CITY PLANNING COMMISSION

- APPLICATION:
- Variance to reduce the required 15 foot rear yard setback between commercial uses and the side yard of residential uses to three feet (Section 3-C-5)
 - Variance to waive the required six foot high masonry wall between residential and commercial uses (Section 3-D-7-a)
 - Lot Line Adjustment to merge four parcels into one parcel (Subdivision Map Act Section 66499.20-3/4)

LOCATION: 2360 Stockton Boulevard

PROPOSAL: The applicant is requesting the necessary entitlements to construct a 7,920± square foot office building in the General Commercial zone

EXHIBIT B

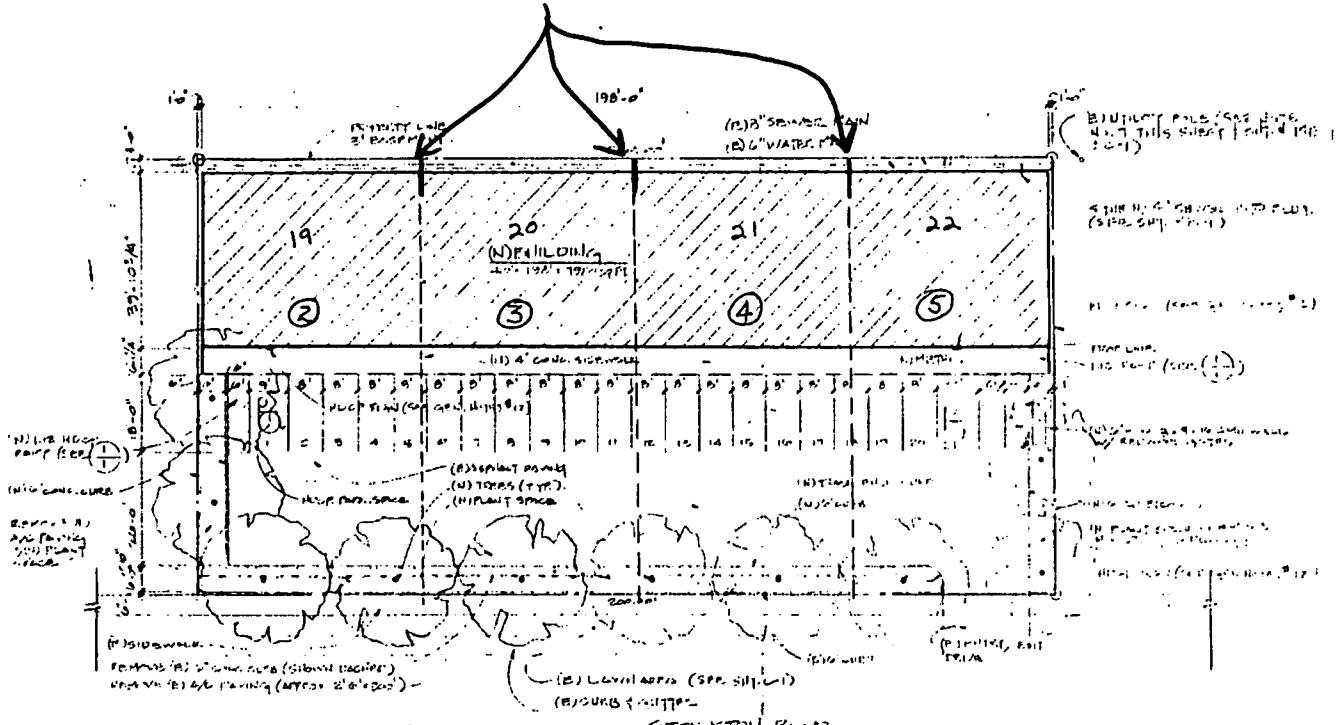
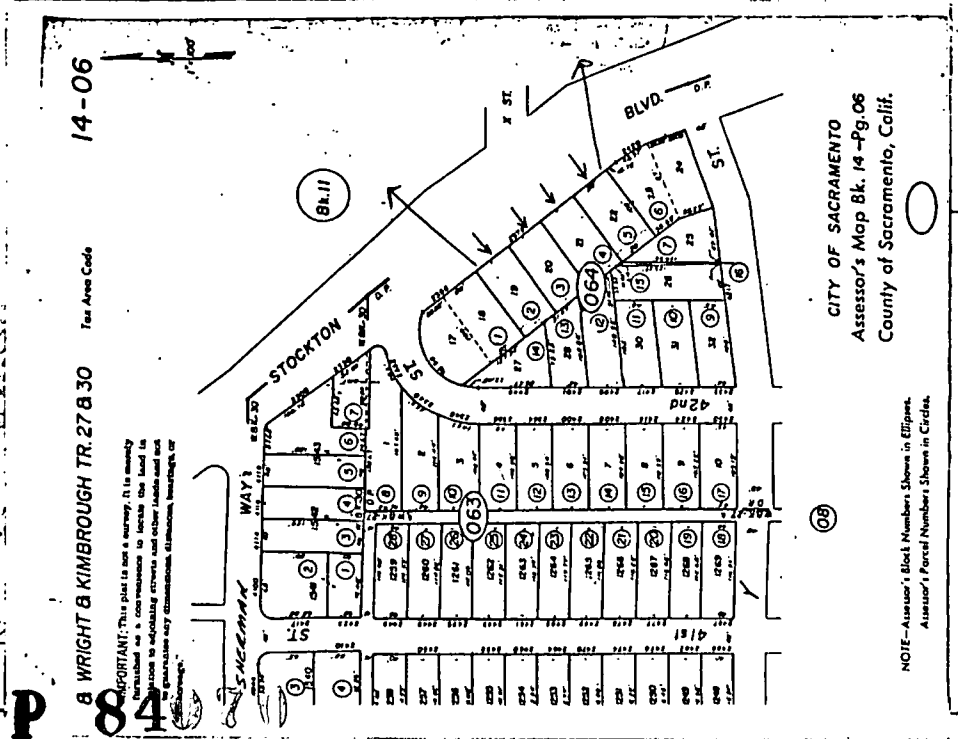
The applicant is requesting a lot line adjustment to merge the four parcels into one and build a 7,920± square foot office building on the site (Exhibits B-E). The applicant proposes to place the rear wall of the building three feet from the rear property line and is also requesting the necessary entitlements to waive the required setback and six foot high masonry wall between residential and commercial uses.

4. The Sewer and Water Division has indicated that a five foot easement, rather than the three foot easement shown on the applicant's plans, is located along the rear property line of the site. The applicant will need to revise the plans for the subject site to accommodate this easement. This may require a reduction in the square footage of the proposed office building. Staff also recommends that the applicant provide a secure gate along the north property line to limit access by unauthorized individuals to this area.

4. The Sewer and Water Division has indicated that a five foot easement, rather than the three foot easement shown on the applicant's plans, is located along the rear property line of the site. The applicant will need to revise the plans for the subject site to accommodate this easement. This may require a reduction in the square footage of the proposed office building. Staff also recommends that the applicant provide a secure gate along the north property line to limit access by unauthorized individuals to this area.

- a. The applicant shall maintain a ^{three} ~~five~~ foot setback along the rear property line for the existing sewer easement.
- b. The applicant shall revise the design of the proposed office building to incorporate the design features outlined in the staff evaluation. The revised design shall be reviewed and approved by the City's Design Review Board prior to issuance of building permits.

- a. The applicant shall maintain a five foot setback along the rear property line for the existing sewer easement.
- b. The applicant shall revise the design of the proposed office building to incorporate the design features outlined in the staff evaluation. The revised design shall be reviewed and approved by the City's Design Review Board prior to issuance of building permits.

EXHIBIT C

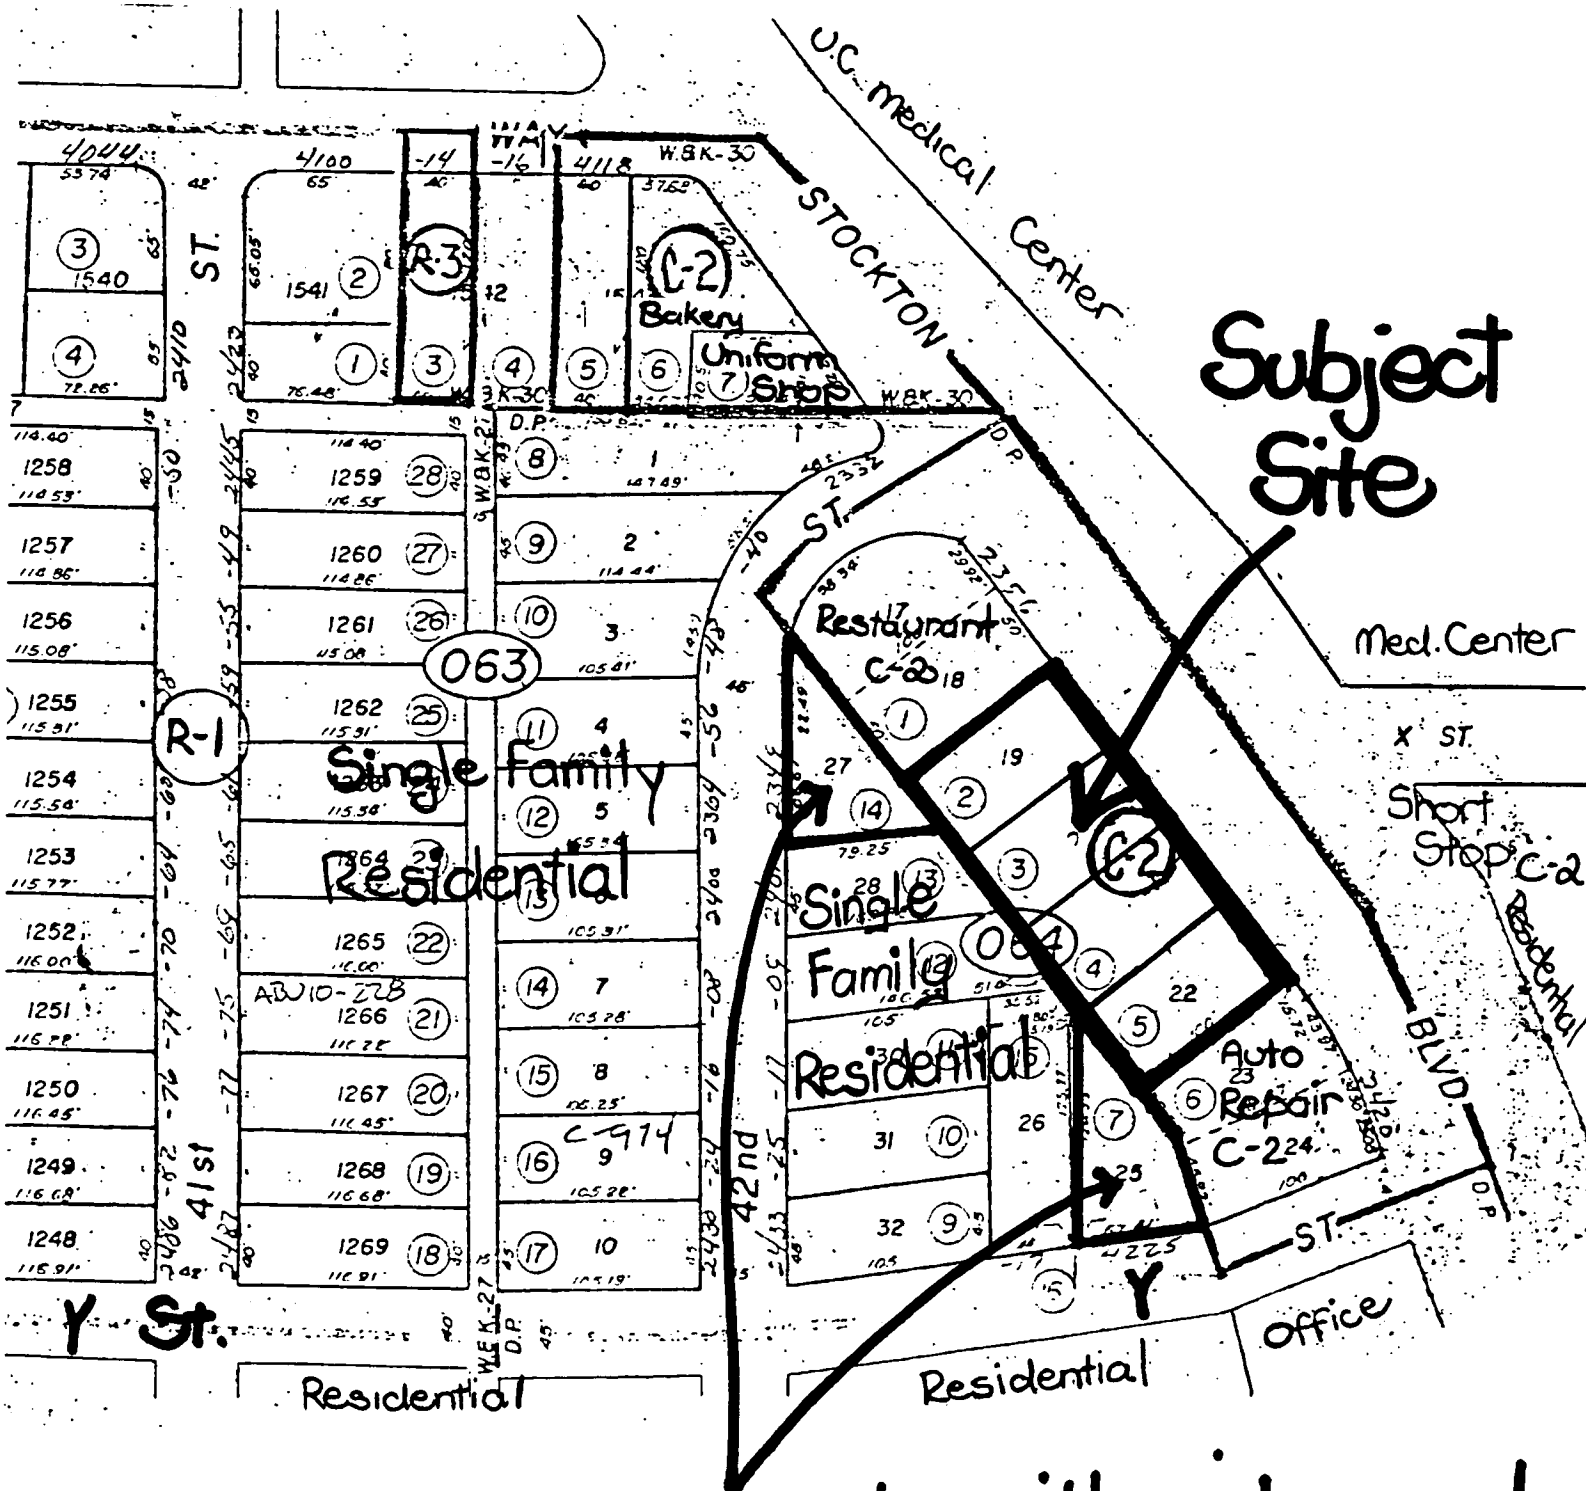
5. Two of the parcels adjacent to the subject site have a portion of their side yard property lines lying adjacent to the rear yard property line of the subject site (Exhibit C). When the side of a residentially-zoned property abuts the rear of a commercially-zoned lot, a 15 foot rear yard setback is required. Due to the irregular shape of these parcels, however, the existing residences on these lots are set back approximately 10 feet from the rear property line of the subject site. In addition, there are wooden fences approximately four feet high separating the residential uses and the subject site. The five foot building setback required for the sewer easement will make the distance between the proposed office building and the residences on the two parcels approximately 15 feet. This setback should provide adequate light, air and fire access between the residential and commercial uses. In addition, requiring the 15 foot setback for the subject site would create an unusable area at the rear of the proposed office building. Staff, therefore, recommends that a variance to reduce the required 15 foot setback to five feet be approved.

5. Two of the parcels adjacent to the subject site have a portion of their side yard property lines lying adjacent to the rear yard property line of the subject site (Exhibit C). When the side of a residentially-zoned property abuts the rear of a commercially-zoned lot, a 15 foot rear yard setback is required. Due to the irregular shape of these parcels, however, the existing residences on these lots are set back approximately 10 feet from the rear property line of the subject site. In addition, there are wooden fences approximately four feet high separating the residential uses and the subject site. The five foot building setback required for the sewer easement will make the distance between the proposed office building and the residences on the two parcels approximately 15 feet. This setback should provide adequate light, air and fire access between the residential and commercial uses. In addition, requiring the 15 foot setback for the subject site would create an unusable area at the rear of the proposed office building. Staff, therefore, recommends that a variance to reduce the required 15 foot setback to five feet be approved.

- 1. Approval of the variance to reduce the required 15 foot building setback, subject to conditions and based upon findings of fact which follow;
- 2. Approval of the variance to waive the required six foot high solid masonry wall, subject to conditions and based upon findings of fact which follow;
- 3. Approval of the lot line adjustment to merge four parcels into one by adopting the attached resolution.

EXHIBIT D

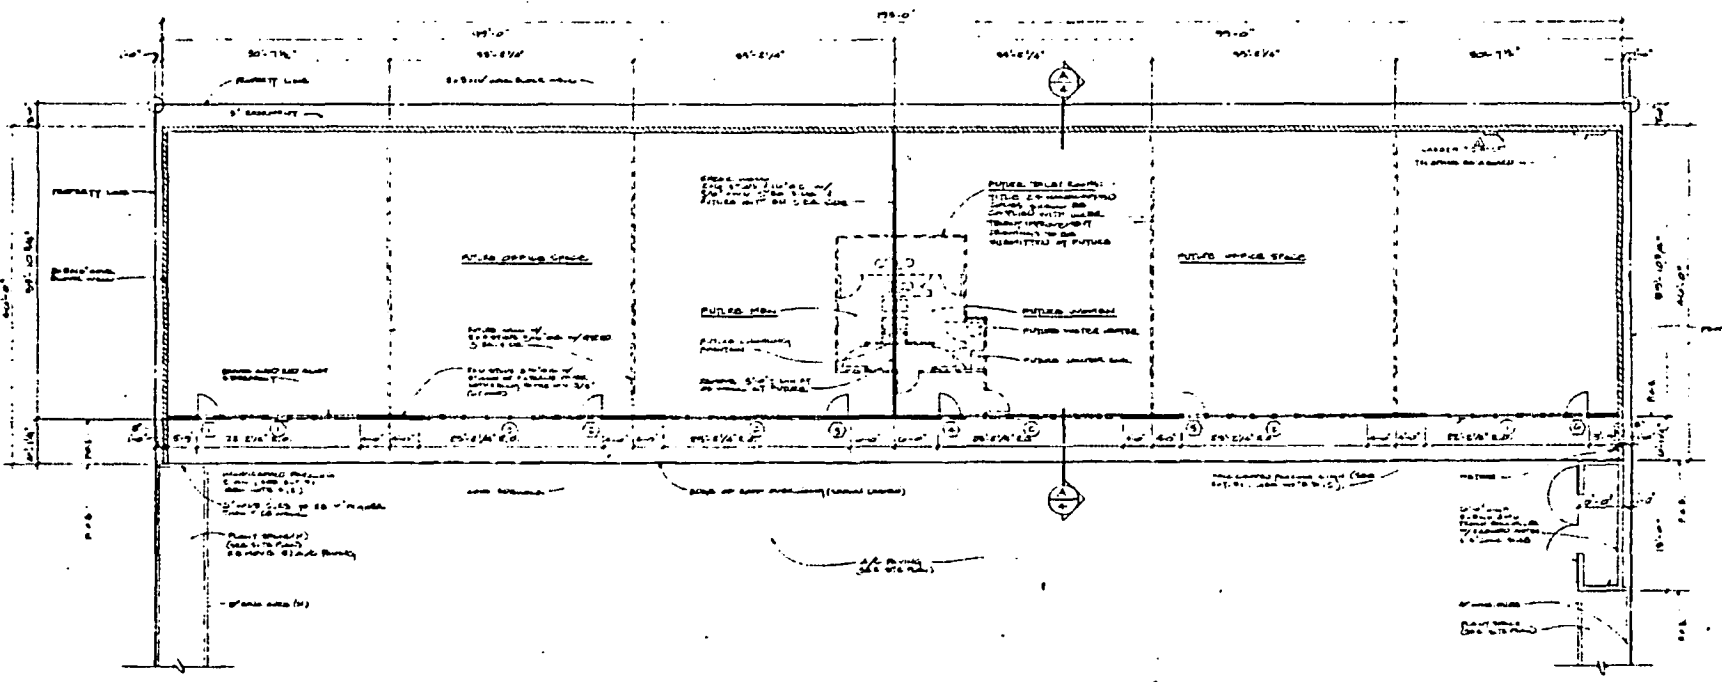
Staff, however, has concerns that the proximity of this flat solid concrete wall to the existing residential uses will have an adverse visual impact on the neighborhood. The proposed height of the building is 16 feet, making the rear and side walls of the structure clearly visible to residences adjacent to the site as well as residences on the west side of 42nd Street and the south side of Y Street (see land use map). Presently, the applicant proposes to use solid concrete block for these walls and paint the building tan and bronze. These walls should be redesigned to incorporate features that will be pleasing to the adjacent residents such as a textured surface block wall and a three dimensional wall treatment. The front facade of the building should also be redesigned to provide some movement rather than the flat facade proposed by the applicant. These changes will create a structure that is more visually compatible with the existing residential neighborhood. Staff, therefore, recommends that the applicant redesign the proposed office building to incorporate these changes. The revised design should be reviewed and approved by the City's Design Review Board prior to issuance of building permits.

Staff, however, has concerns that the proximity of this flat solid concrete wall to the existing residential uses will have an adverse visual impact on the neighborhood. The proposed height of the building is 16 feet, making the rear and side walls of the structure clearly visible to residences adjacent to the site as well as residences on the west side of 42nd Street and the south side of Y Street (see land use map). Presently, the applicant proposes to use solid concrete block for these walls and paint the building tan and bronze. These walls should be redesigned to incorporate features that will be pleasing to the adjacent residents such as a textured surface block wall and a three dimensional wall treatment. The front facade of the building should also be redesigned to provide some movement rather than the flat facade proposed by the applicant. These changes will create a structure that is more visually compatible with the existing residential neighborhood. Staff, therefore, recommends that the applicant redesign the proposed office building to incorporate these changes. The revised design should be reviewed and approved by the City's Design Review Board prior to issuance of building permits.
